CITY OF SAVANNAH

HISTORIC PRESERVATION COMMISSION

REQUEST FOR CERTIFICATE OF APPROPRIATENESS

Petitioner: Array Design, Shauna Kucera
MPC File No.: 26-003779-COA
Address: 207 West 43rd Street
PIN: 20074 22006
Zoning: TC-1
Staff Reviewer: Caitlin Chamberlain
Date: September 23, 2026

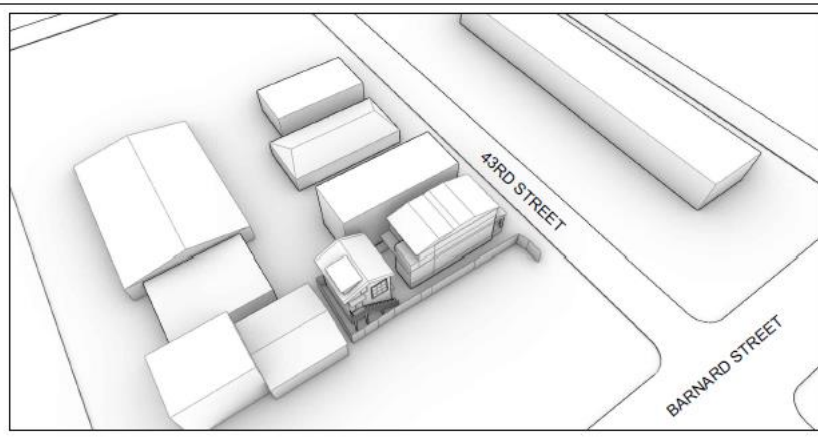
Rhythm of Building or Structure. The relationship of a building or structure to the open space between it and adjacent buildings or structures shall be visually compatible with the open spaces between contributing buildings or structures to which it is visually related.

There is adequate space between the principal building and the ADU, which allows for visual compatibility. There is an uncommon arrangement with the lack of a street or lane at the rear of the property, which has created a situation of buildings on the opposite side being closer than they would be if they were across a lane. As seen in the image below, there is still an appropriate spacing and rhythm.
